HORIZON®. HRZ-D MANUAL
ADDENDUM
June 1980

ADDENDUM to: HRZ-D MANUAL, REVISION_1

JUNE 4, 1980

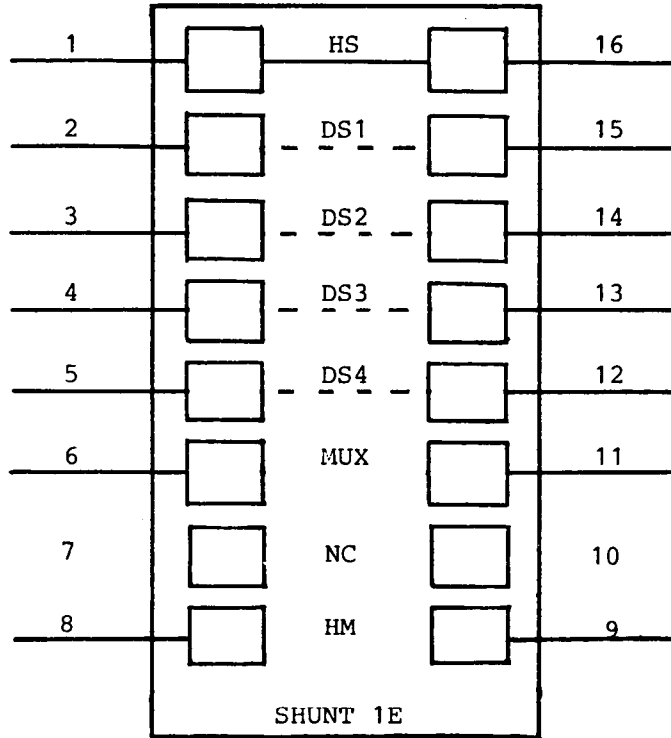
- 2) The HRZ-D Manual is the proper documentation for North Star's quad capacity HORIZON, HRZ-Q. Quad capacity HORIZON systems are essentially the same as double density HORIZON systems (HRZ-D). They differ from double density systems in that the one or two drives included with quad capacity system are quad capacity drives and not double density drives, as included in a double density system. Furthermore, the blank diskette included with a quad capacity HORIZON system is a double-sided diskette, not a single-sided diskette as included with double density HORIZON systems. In all other ways, the quad capacity HORIZON systems are the same as the current double density HORIZONS.
- 3) The capacitors C5, C6, C8, and C9 will no longer be installed in the HORIZON motherboard. Make the following changes to the HRZ-D Manual, Rev. 1:

PARTS LIST CHANGES

- A. On page 12, in the section titled DISK SUB-SYSTEM (MDS-H) PARTS LIST, delete two .047uf ceramic capacitors from the parts list.
- B. On Page 13, in the section titled SECOND DISK DRIVE (HRZ-DRV) PARTS LIST, delete two .047uf ceramic disc capacitors from the parts list.

INSTRUCTION CHANGES

- A. On page 37, delete instruction D1 in the section titled DISK DRIVE #1 POWER REGULATION ASSEMBLY.
 - B. On page 38, delete instruction E1 in the section titled DISK DRIVE #2 POWER REGULATION AND CABLE ASSEMBLY.

DOUBLE-SIDED DRIVE SELECT CONFIGURATION

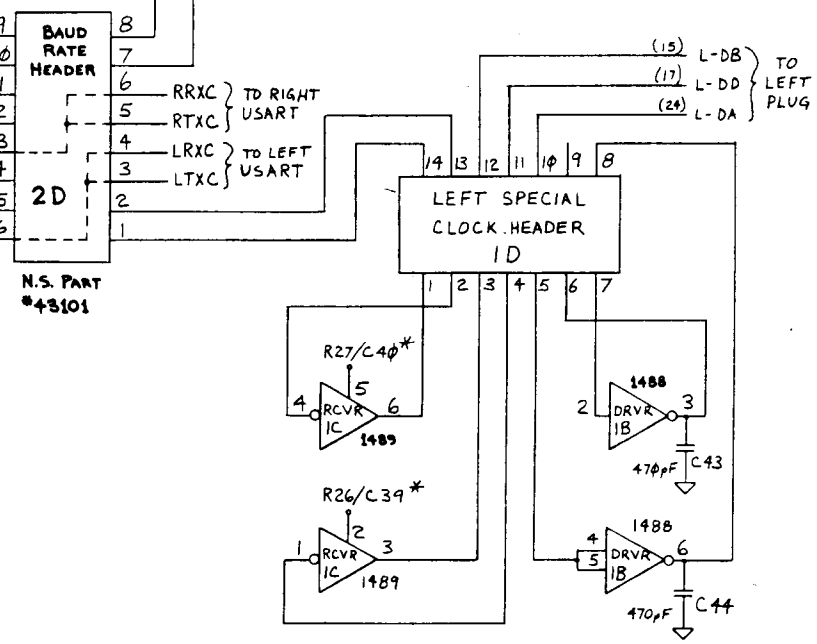
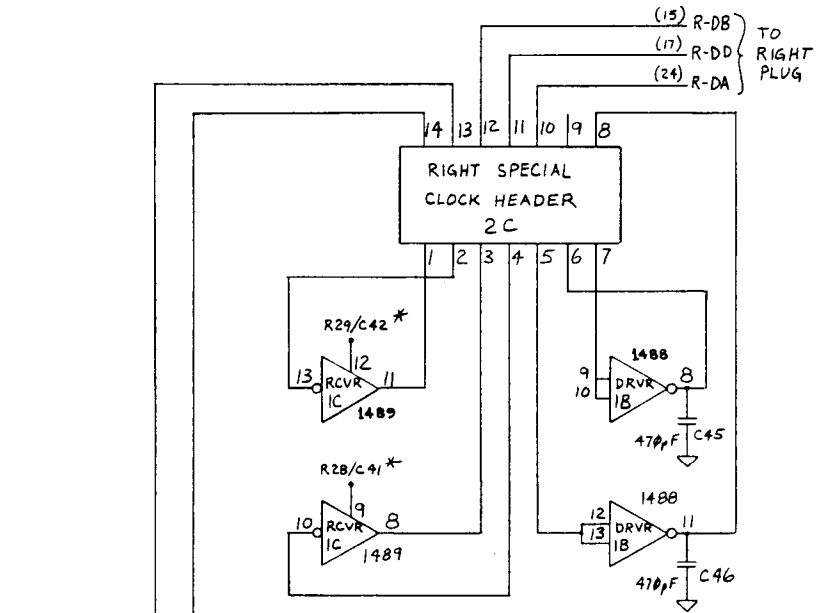
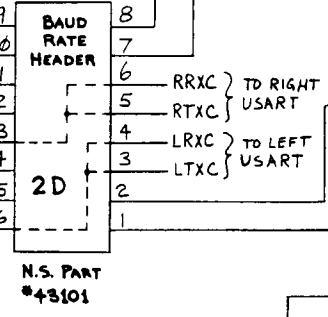
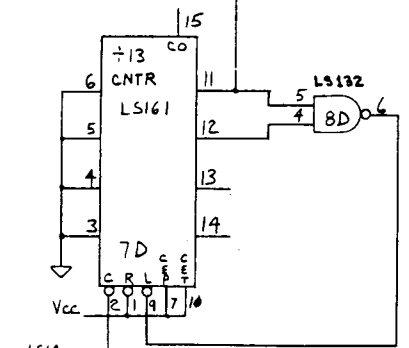
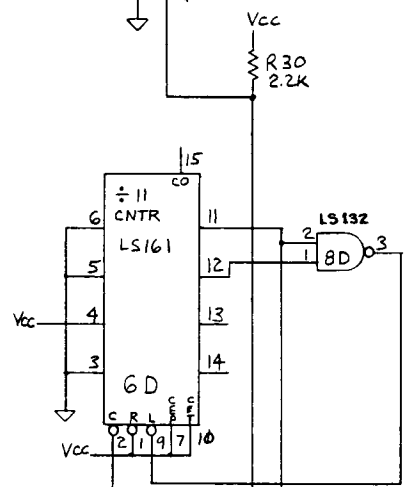
- 10) When using a doubled-sided drive, make certain that the shunt at 1E is properly configured. The connection for HS (Head Select) is connected between pin 1 and 16. To select drive one, (DS1), connect pin 2 to pin 15. To select drive two, (DS2), connect pin 3 to pin 14. To select drive three, (DS3), connect pin 4 to pin 13. To select drive four, (DS4), connect pin 5 to pin 12 and to pin 34 of edge connector J1; also, cut trace from pin 6 of the edge connector. Pin 6 and 11, the (MUX shunt), pins 8 and 9 (the HM shunt) and pins 7 and 10 should not be connected. For proper pin configurations, see the "Double-Sided Drive Select Configuration" diagram on the next page.

- Only the drive plugged in at the end of the ribbon cable should have the DIP resistor network at location 2F plugged in. Additional drives plugged in along the cable should have the resistor package removed.

HORIZON MOTHERBOARD HRZ-MB-4	SHT
SERIAL PORTS	3 OF 5
© 1977, NORTH STAR COMPUTERS, INC.

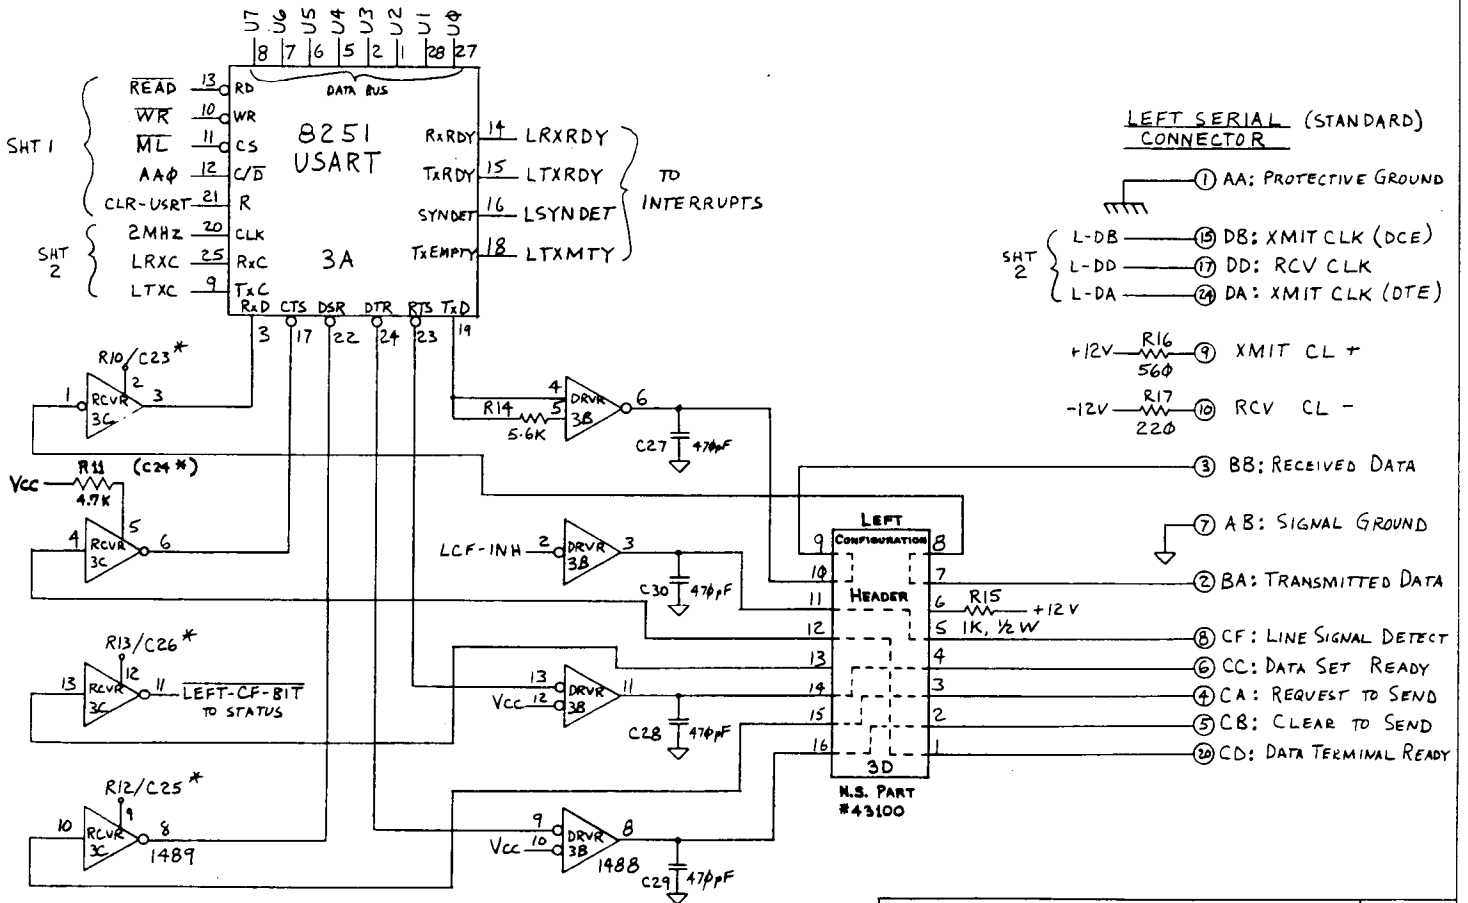
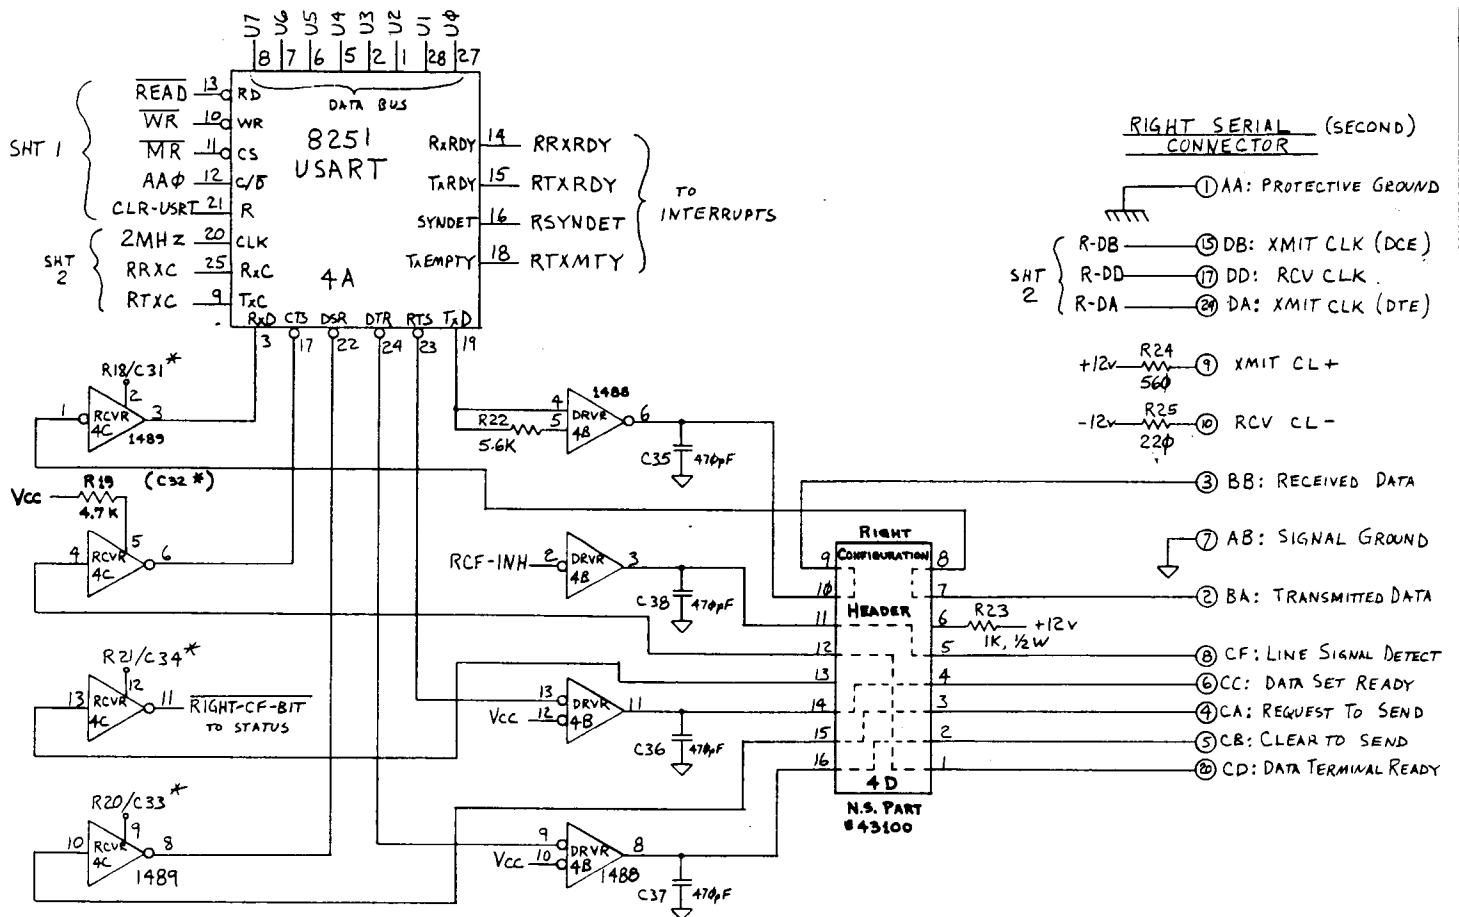
* NOTE: TO EACH RS232 RECEIVER (12 PLACES), USER MAY ADD RESISTOR TO Vcc OR CAPACITOR TO GND. (4.7K RESISTOR NOMINALLY INSTALLED AT PIN # 5)

HORIZON MOTHERBOARD HRZ-MB-4		SHT
BUFFERS, STATUS, PARALLEL PORTS		4 OF 5
© 1977, NORTH STAR COMPUTERS, INC.

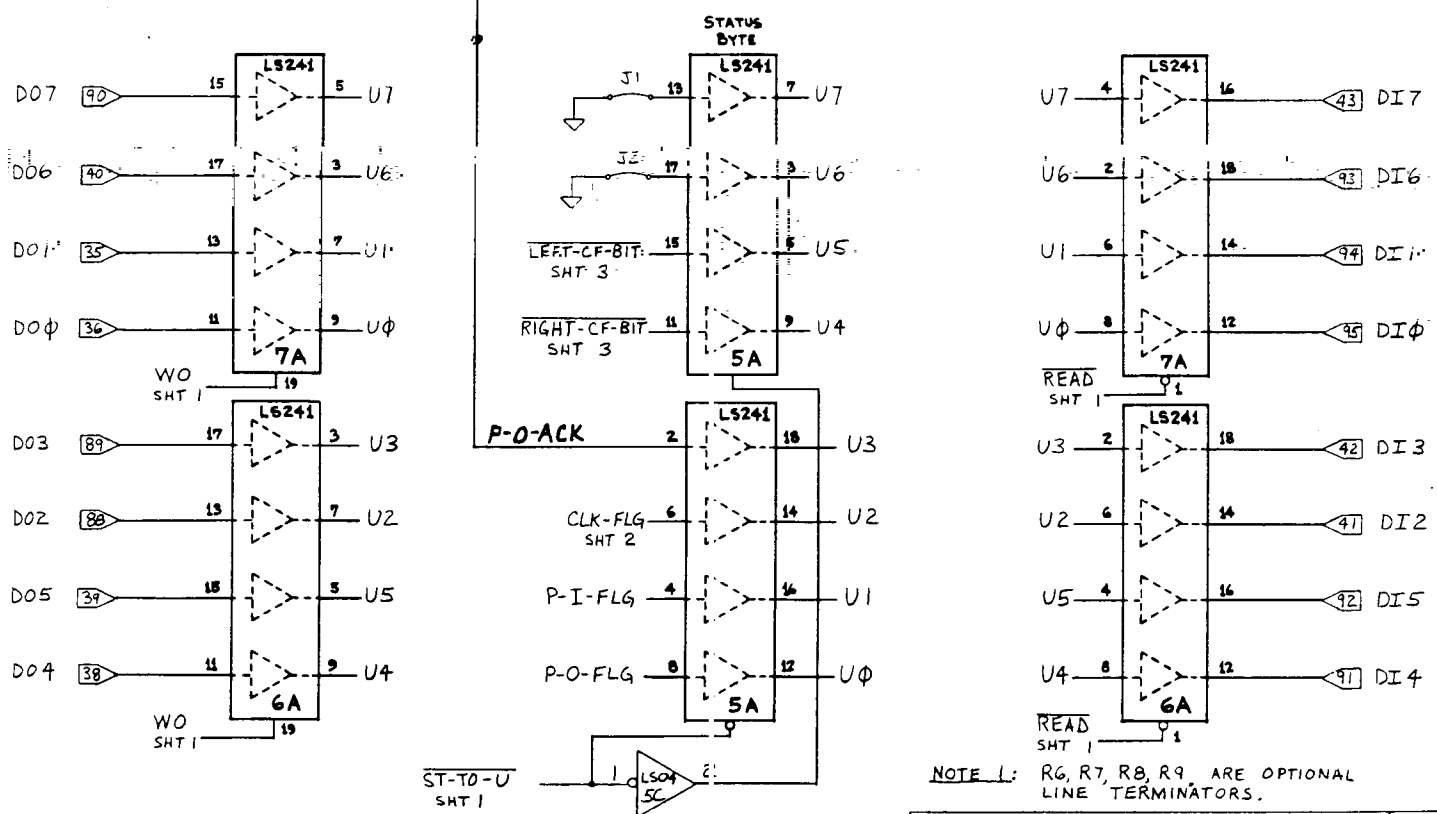
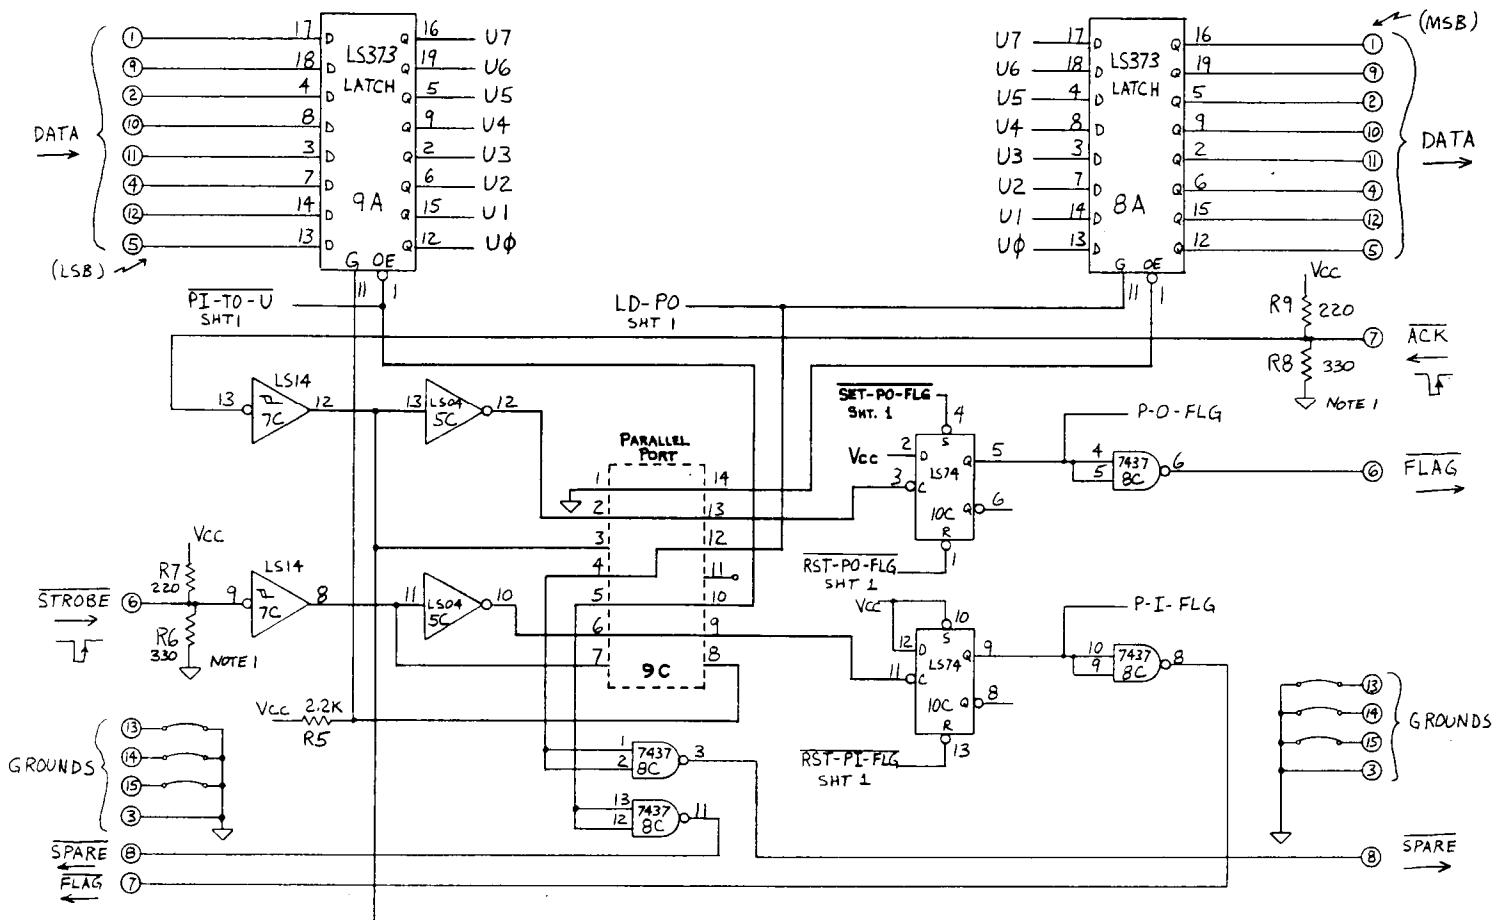
NOTE 1: R6, R7, R8, R9 ARE OPTIONAL LINE TERMINATORS.
